The Hall School
23 Crossfield Road,
Hampstead, NW3 4NU
The Hall School

Response to Eldred
Geotechnics Report:
Technical Advice
G1701-TA-01-EA
EW Comments

Job number: 2150206
Revision: P2
Status: Preliminary
Date: April 2017

FIGURE 1 Existing arrangement of 24 Crossfield Road 1998

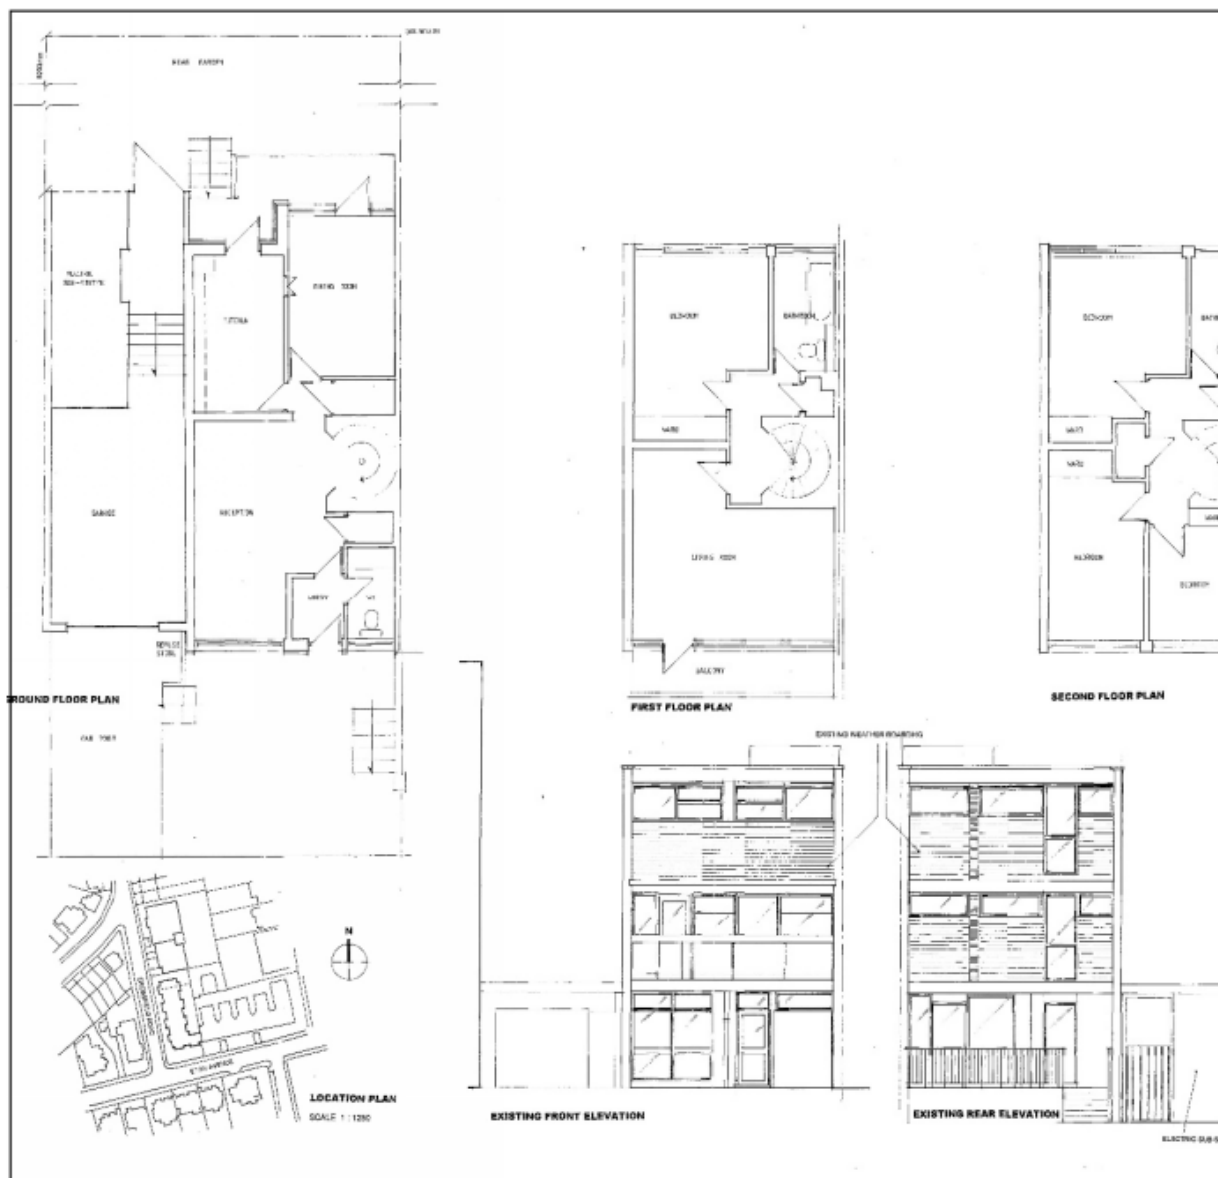
37. *Figure 1 below is taken from a 1998 planning application for No.24 and shows the arrangement of the property at that time. The application was to remove the garage and extend to the boundary. It was refused and so the current arrangement is unlikely to differ very much from that shown. The construction of the front and back walls of the houses is of material significance for this case. Like many other housing terraces of the time, it followed the architectural fashion to have glazing that extended for the full width of the houses at all floor levels, with tiled or other probably non-brickwork apron walls below.*

38. *In this case it can be seen that most of the glazing and doors in the ground floor of No. 24 are full height on both elevations. On the front elevation there is at least one full height opening to the balcony and possibly a full height glazed panel. On the rear elevation there are full height glazed panels at both first and second floors.*

39. *Solid parts of walls between and below these openings were difficult to stabilise if made of brickwork and so were often timber framed, the frames being made on site and supported by being fixed to verticals between openings and to party and flank walls. Usually, as in this case, there were no continuous internal cross walls and it was only the structure between openings in the front and back walls that provided lateral stability to the terrace as a whole and stopped the "pack of cards " effect.*
